U.S. Department of the Interior BUREAU OF LAND MANAGEMENT

Notice of Intent

Type of Action: APD Change

Top Spot KPLA Bulk Sundry

Figure C] 4 – String – Un Cemented Annulus

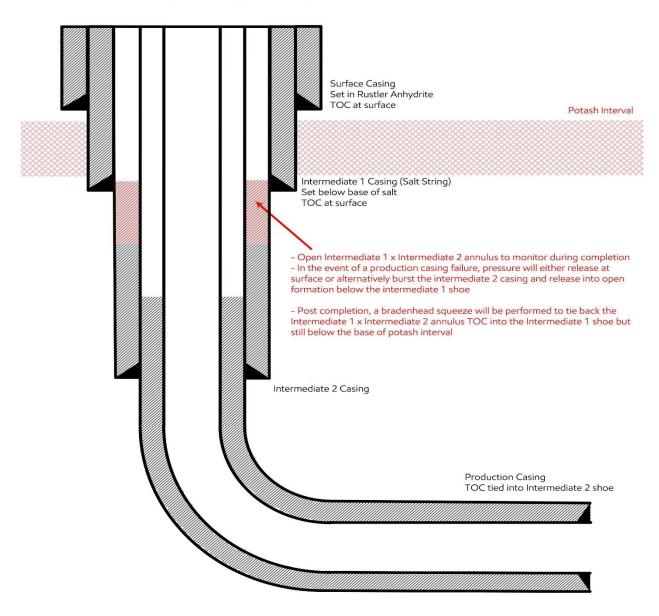
Oxy requests to update the Deep Intermediate Cement Job to align with the agreed upon R111-P updates presented from the JITC. I've included 4 tables below due to the different target benches:

4-String Design - Open Int 1 x Int 2 Annulus

ALL PREVIOUS COAS STILL APPLY. CEMENT DESIGN UPDATE AS PER KPLA BEST PRACTICES (4-STRING INT1 X INT2 OPEN ANNULUS)

Operator has proposed to pump down 7-5/8" X 9-5/8" annulus POST-FRAC.

Operator must top out cement after the bradenhead squeeze and verify cement to surface. Operator can also check TOC with Echo-meter. CBL must be run from TD of the 7-5/8" casing to surface if confidence is lacking on the quality of the bradenhead squeeze cement job. Submit results to BLM.
